SNUPPS

Standardized Nuclear Unit
Power Plant System

April 17, 1984

SLNRC 84-0069 FILE: 0278
SUBJ: Revision in Diesel Generator
Start Time

FIGURE 15.6-14
FLUID TEMPERATURE
DECLG ($C_D = 0.6$)

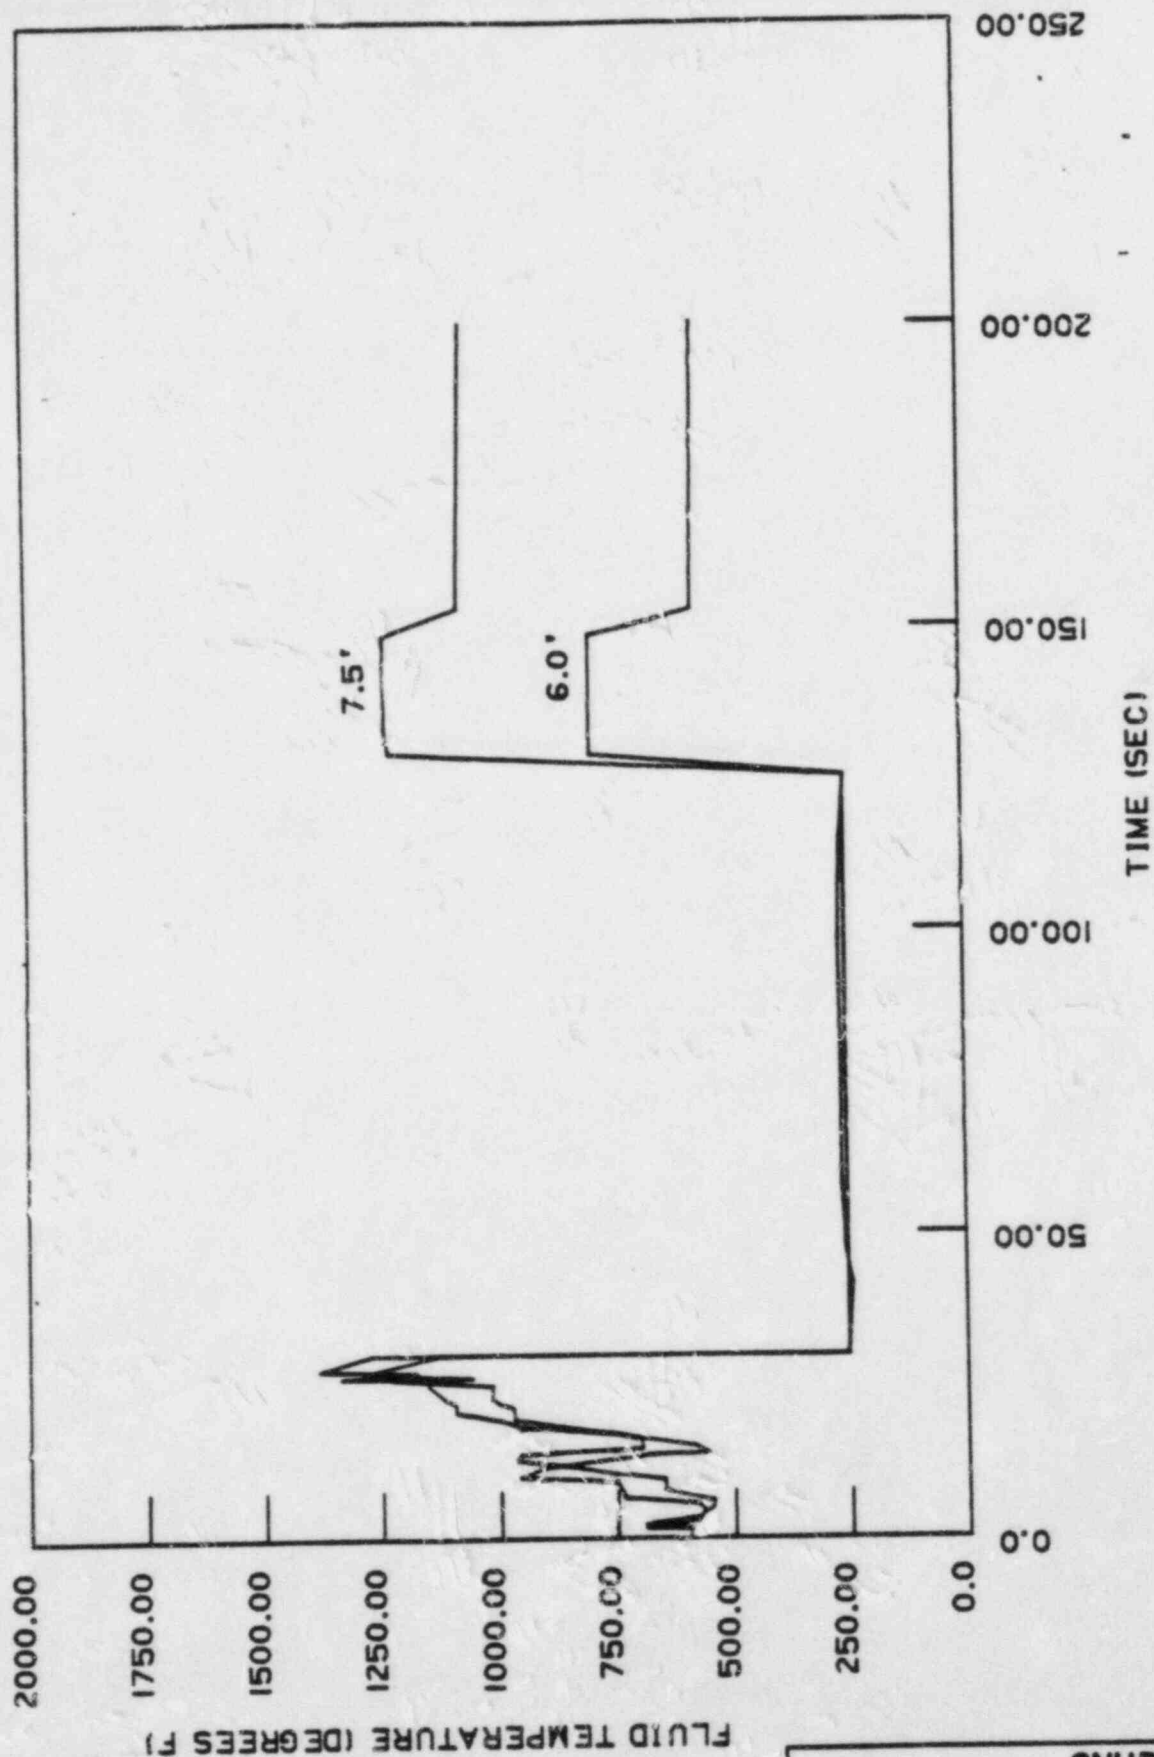
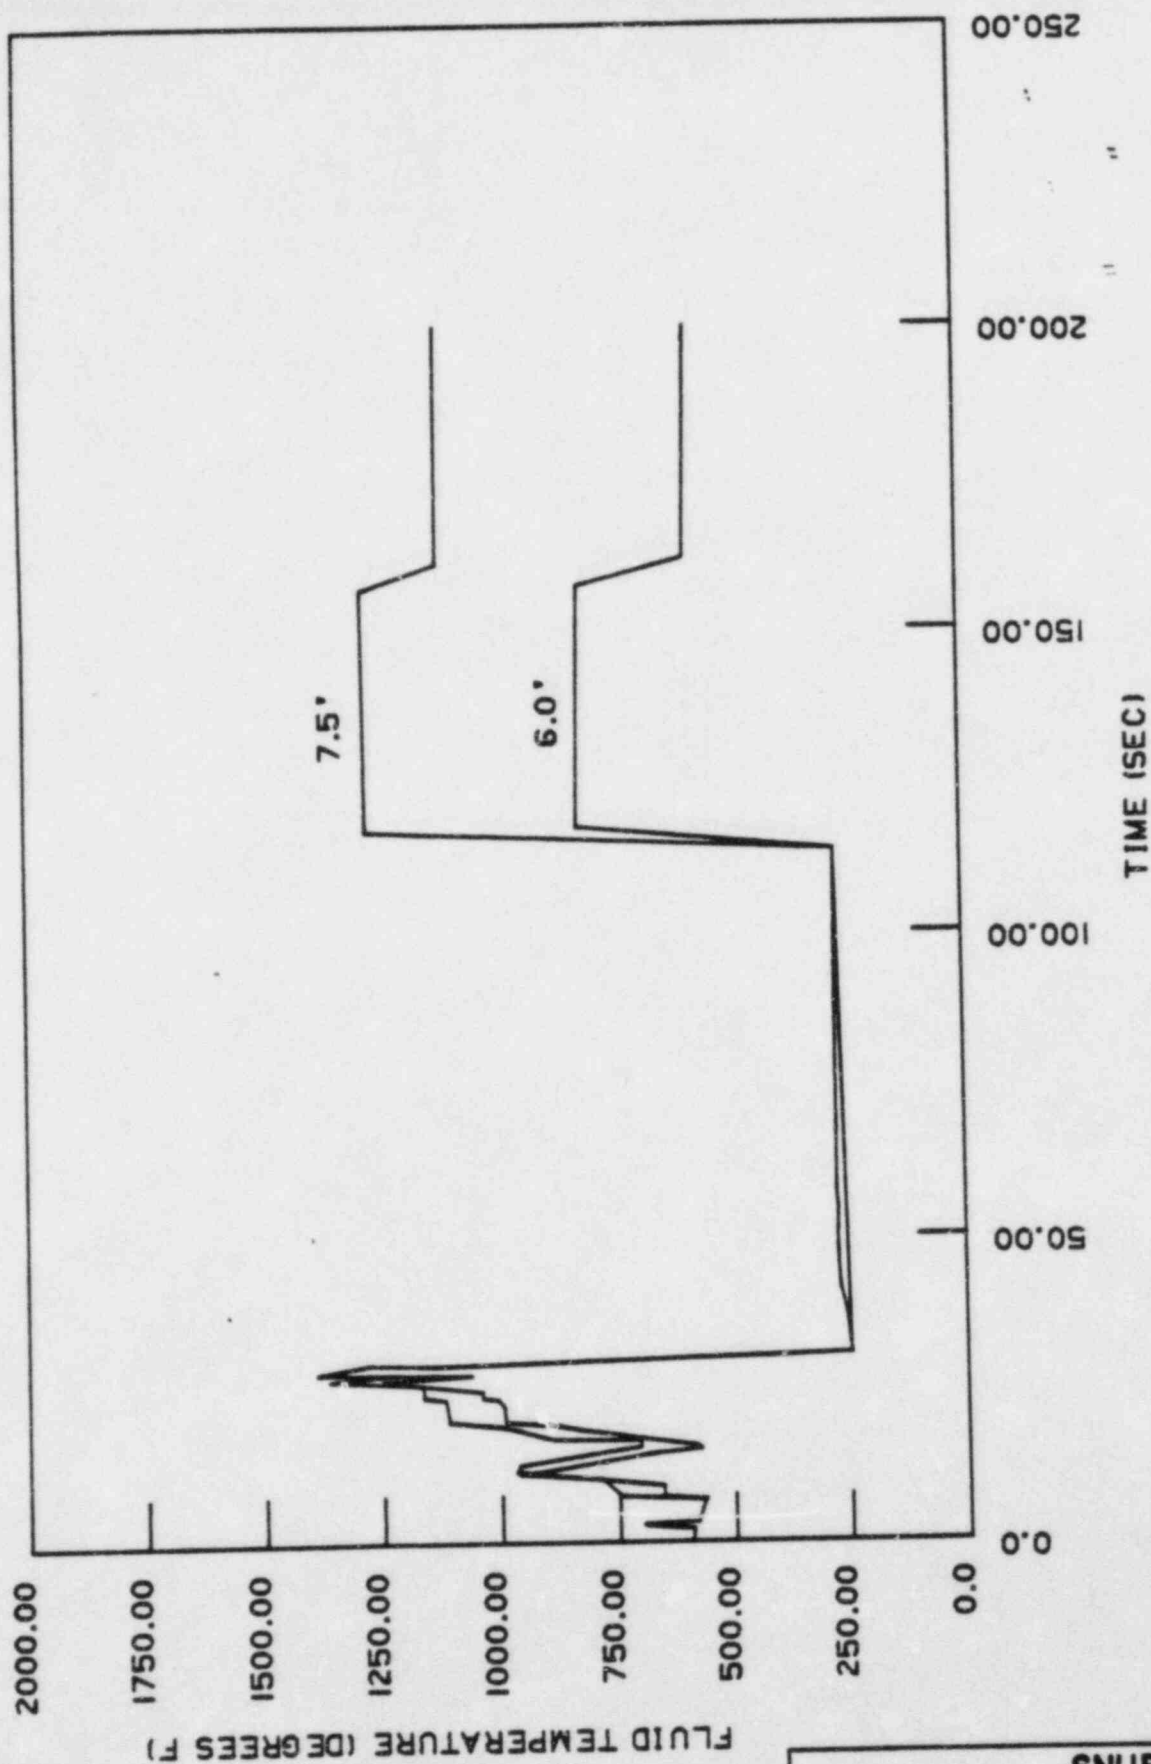
12 SEC
DIG START

FIGURE 15.6-217
FLUID QUALITY
DECL G ($C_D=0.6$)

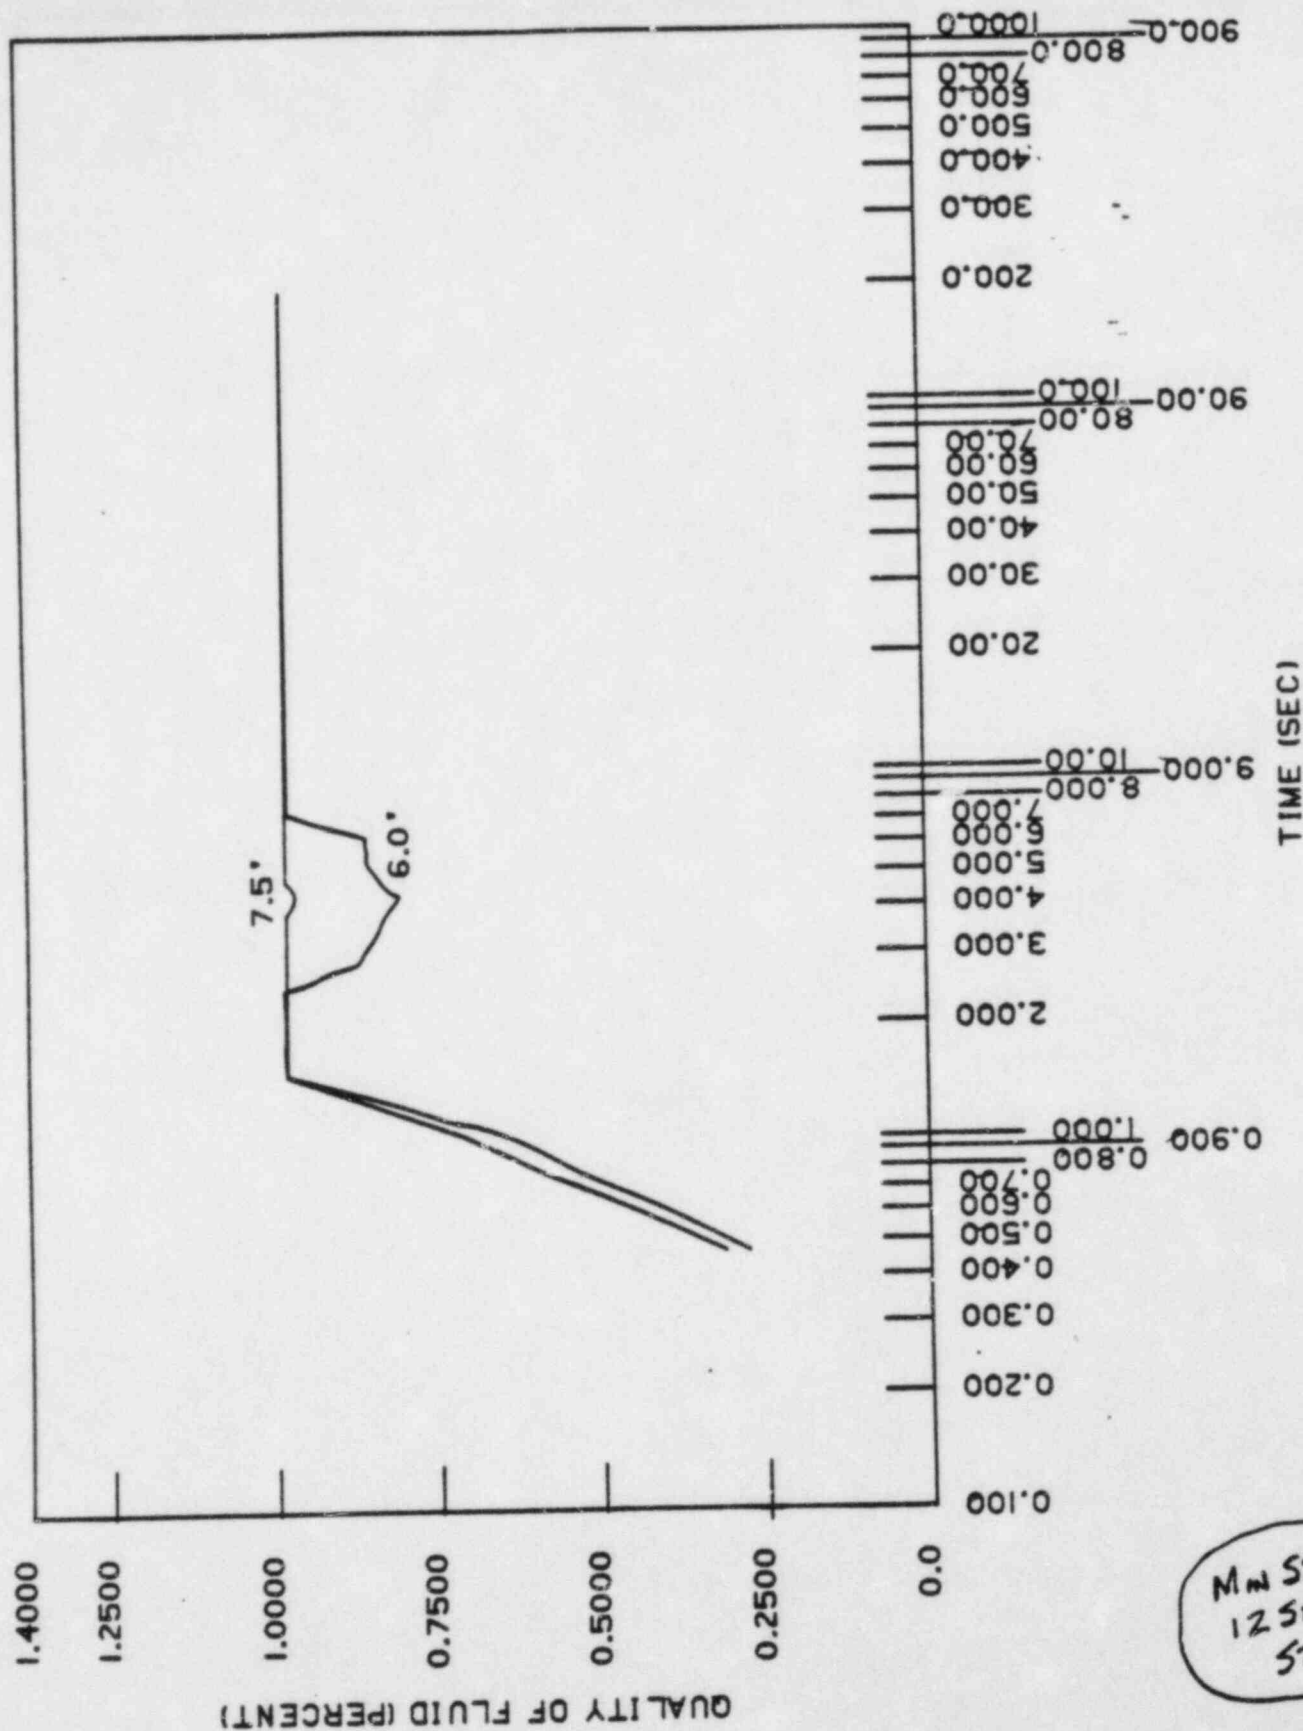
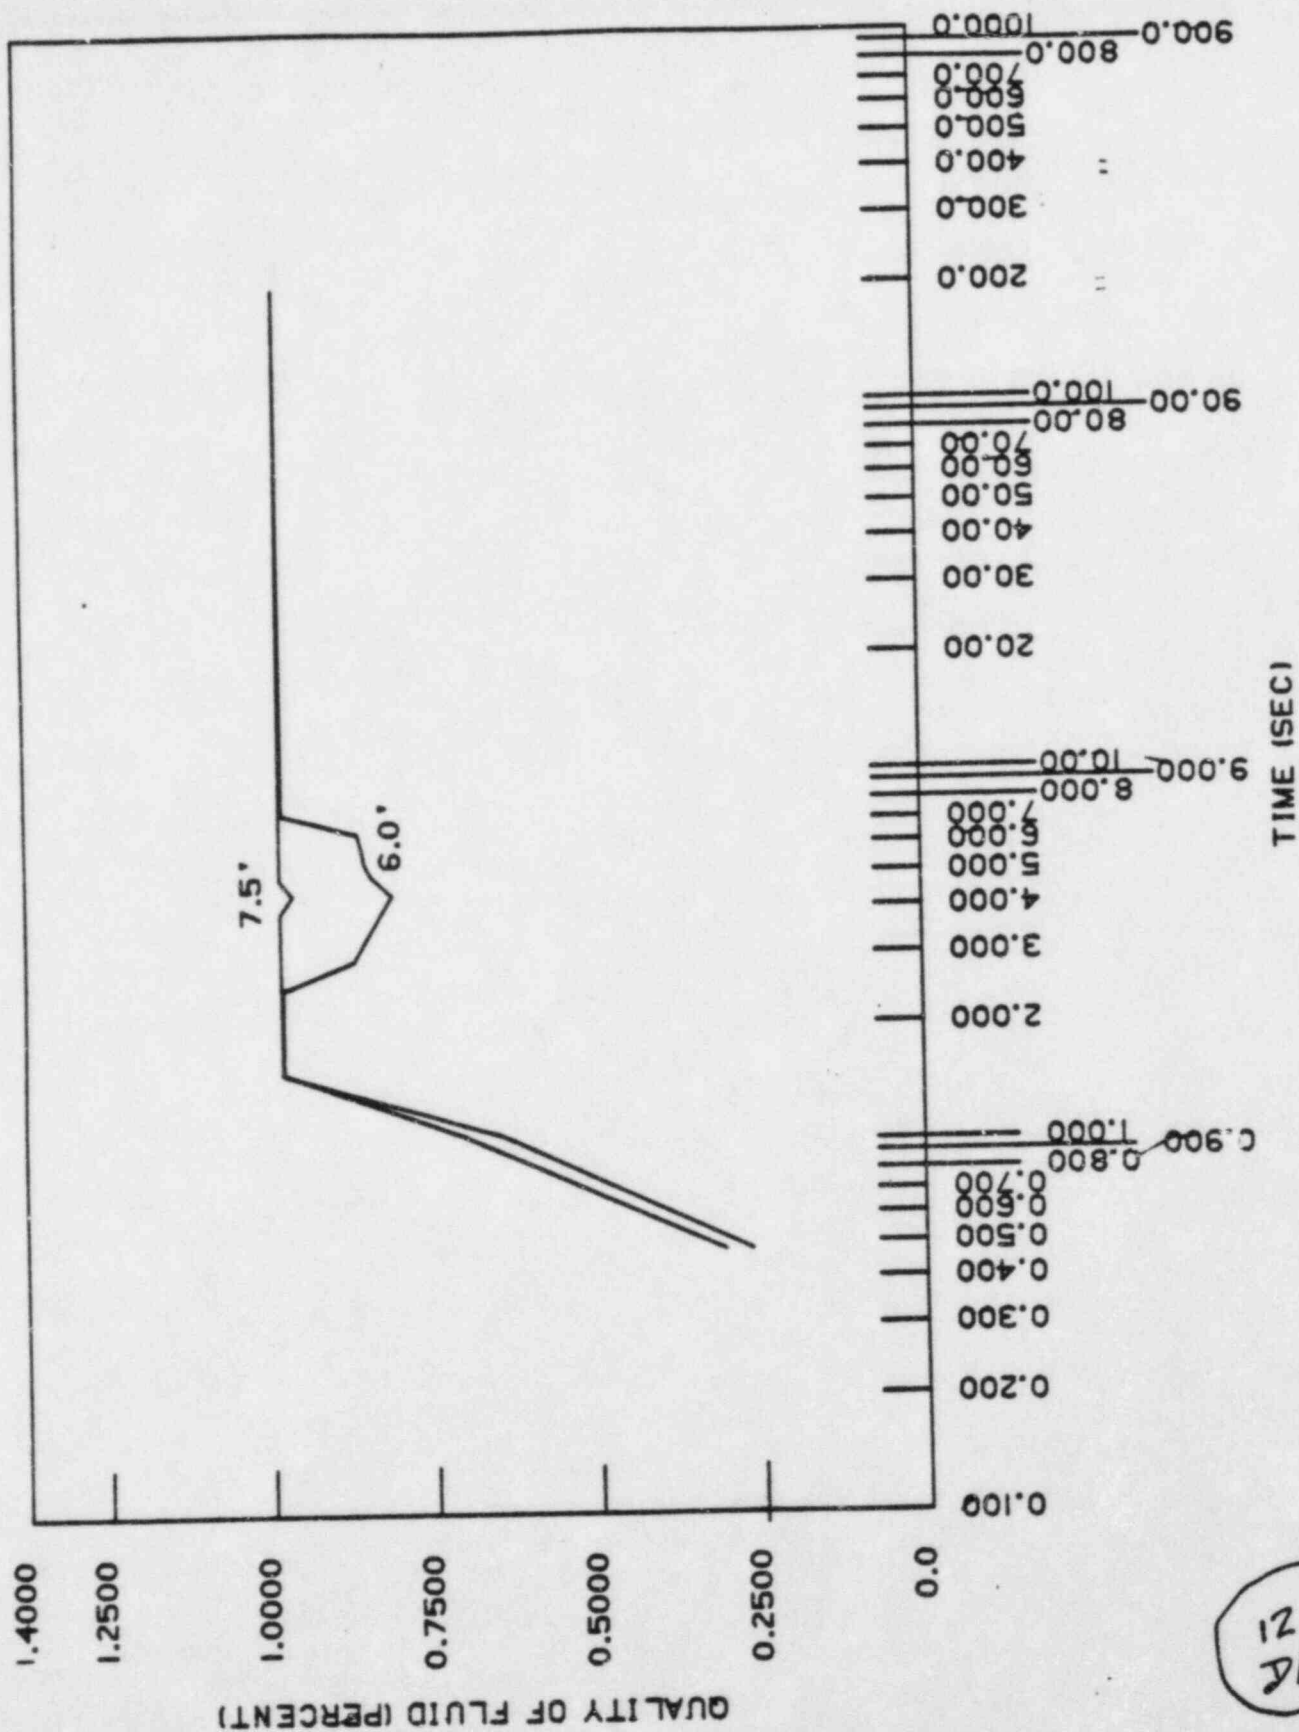
12 SEC
DIG START

FIGURE 15.6-17a
FLUID QUALITY
DECLG IC_D=0.6 MAX SI

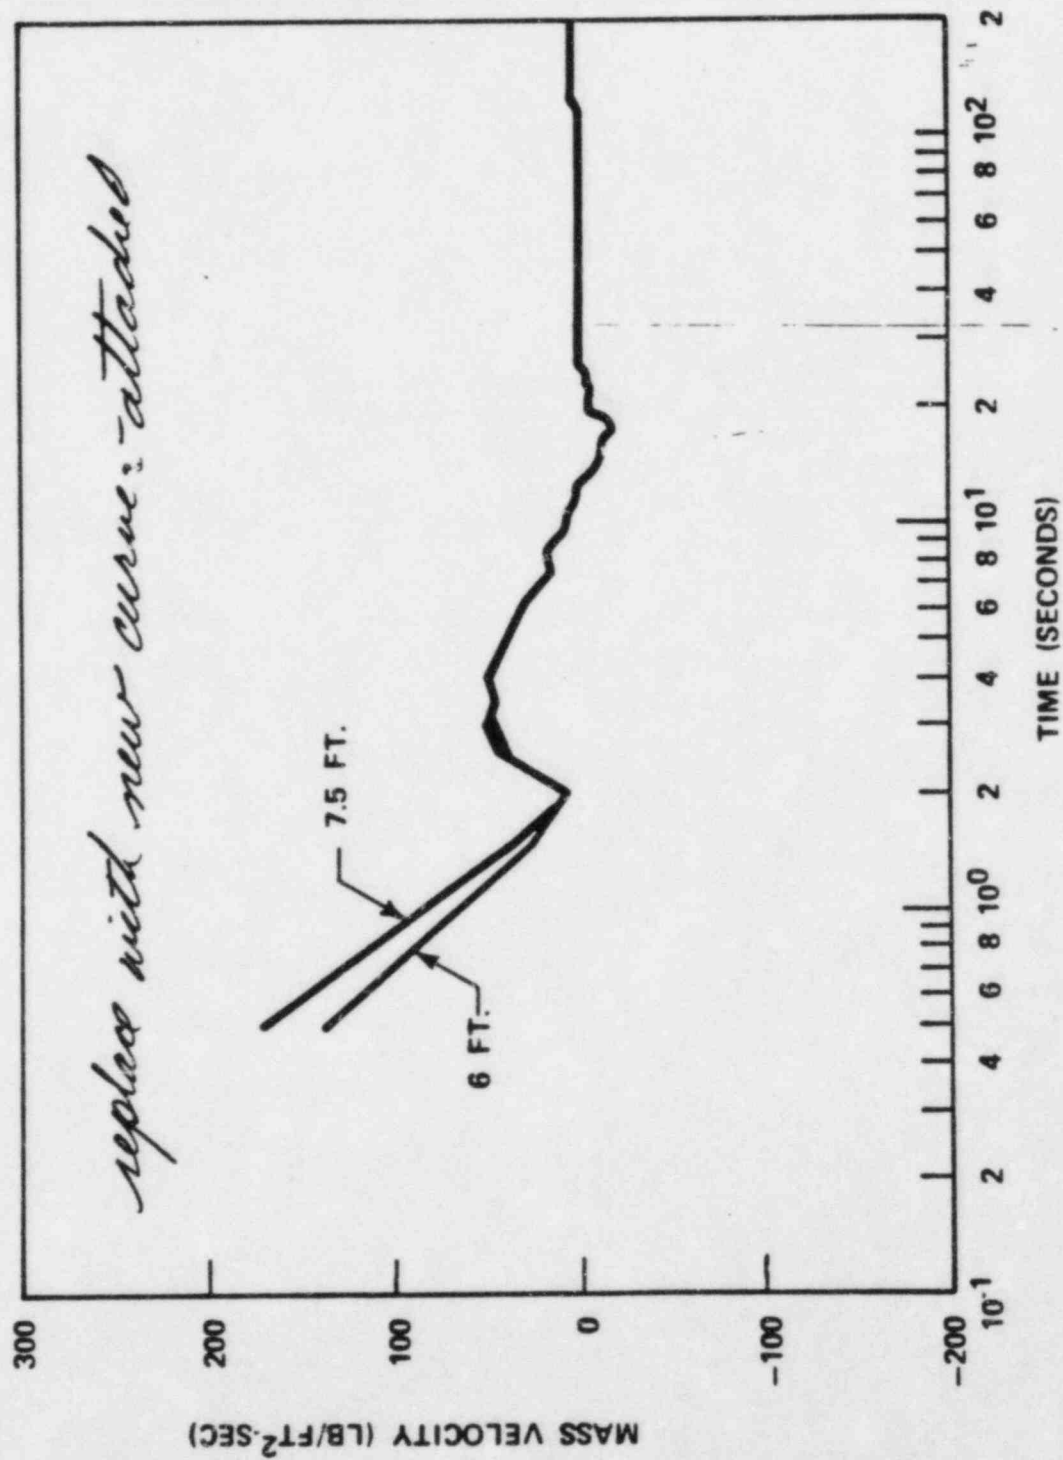
The worst break in the spectrum of break sizes analyzed was a discharge coefficient (C_d) of 0.6. This worst break was analyzed with a 12 second diesel generator start time, to study the effect of a 2 second delay in the start of the diesel generator. Two cases are presented in Table 15.6-11 for the $C_d = 0.6$ DECLG break: The minimum safety injection case and the maximum safety injection case (Reference 27 methodology). The maximum safety injection case proved to be the most limiting.
